MEMORANDUM DATE: April 7, 2021

RE: **122 South K Street**

TITLE: HRPB Project Number 21-00100074: A request for a Certificate of Appropriateness (COA) for the demolition of a ±115 square foot rear enclosed porch, the construction of a new ± 789 square foot addition, and the construction of a new ± 409 square foot accessory structure for the single-family residence located at 122 South K Street; PCN #38-43-44-21-15-047-0060. The subject property is located within the Medium Density Multi-Family Residential (MF-30) zoning district and is a contributing resource to the Southeast Lucerne Local Historic District.

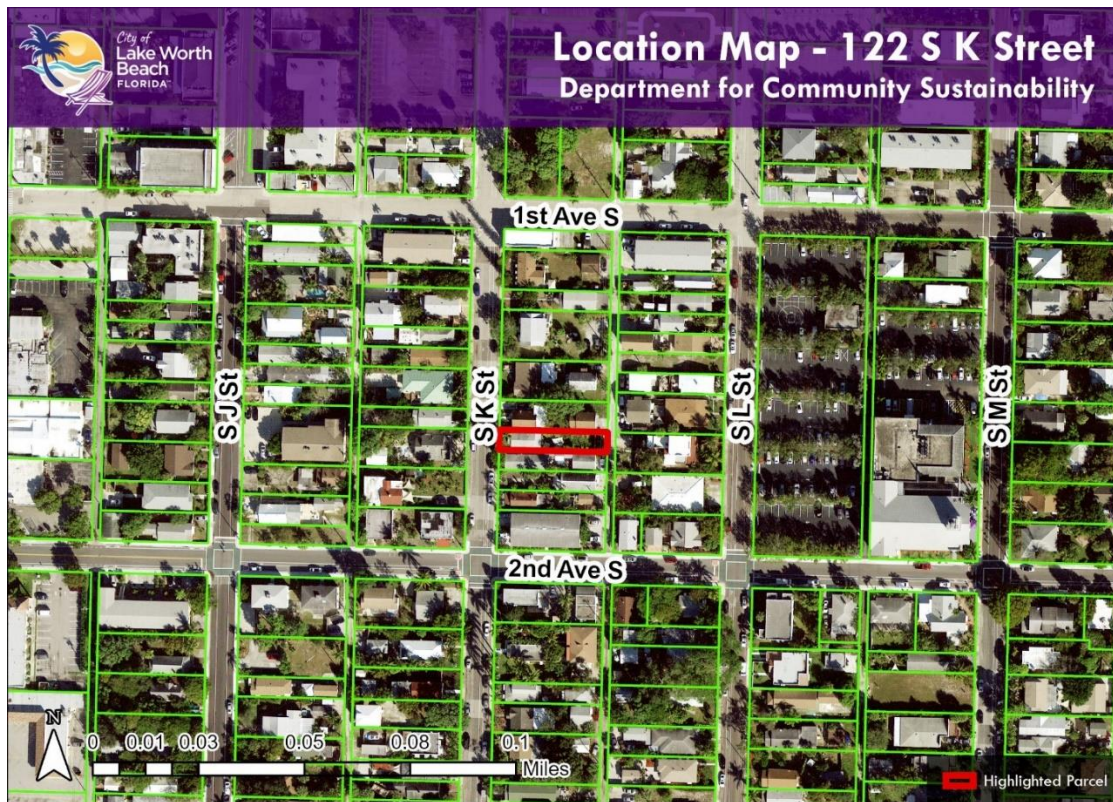
At the March 10, 2021, HRPB regular meeting, the Board reviewed conceptual plans for the project, presented by Juan Contin and Faten Almosawi of Contin Architecture and Design. Primary discussion topics included the massing and visual compatibility of the second-story portion of the addition that will be visible from South K Street, the window proportions, roof design, and exterior siding materials. The Board also recommended that the project utilize a glass or transparent hyphen to connect the historic structure to the addition.

The Board looked at various example projects that utilized highly stylized modern additions to historic structures. Board member comments indicated some of the example projects were highly successful, but that the additions were generally all subordinate to the historic structures and that the historic structures provided in the examples were more elaborate and high-style than the architecture generally found in Lake Worth Beach.

Staff received the formal application for the item on March 18, 2021. Based on a review of Board member comments and the original presentation, alterations to the project include the addition of a transparent hyphen connecting the addition to the rear of the historic structure and the alteration to a window on the west façade.
